UNITED STATES PATENT AND TRADEMARK OFFICE

Office Action Summary

10/765,708

DETAILED ACTION

Modified Fig. 3

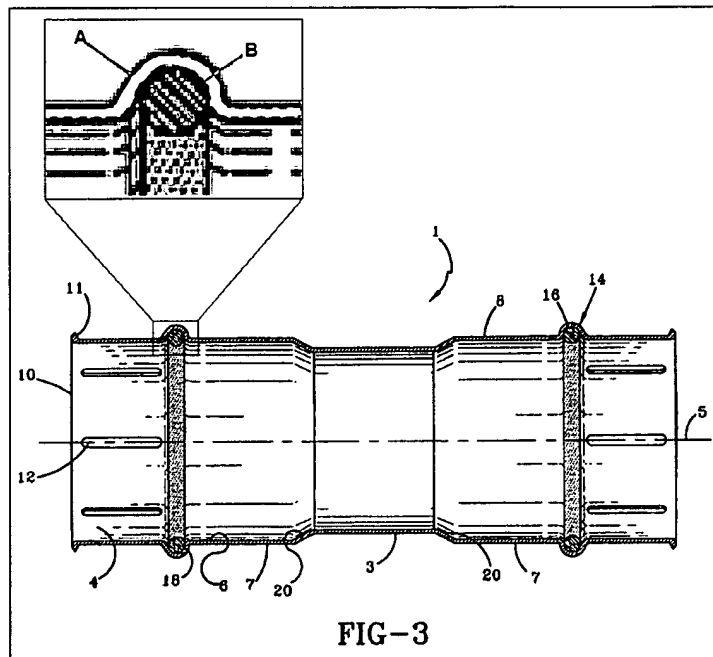
9. Claims 11-12, and 13-14 are rejected under 35 U.S.C. 102(e) as being clearly anticipated by Bishop et al. (U.S. Pat. No. 6,843,516). Bishop discloses a rigid tube having a first end connectable to an exhaust outlet of a combustion engine (Fig. 3, No.

11), the tube including an inner diameter (Modified Fig. 3, No. B), the inner diameter having at least two rings mounted thereto (Fig. 3, No. 16 and 18), each ring having an outer diameter the same as the inner diameter of the tube and an inner diameter smaller than the inner diameter of the pipe (Modified Fig. 3, No. B).
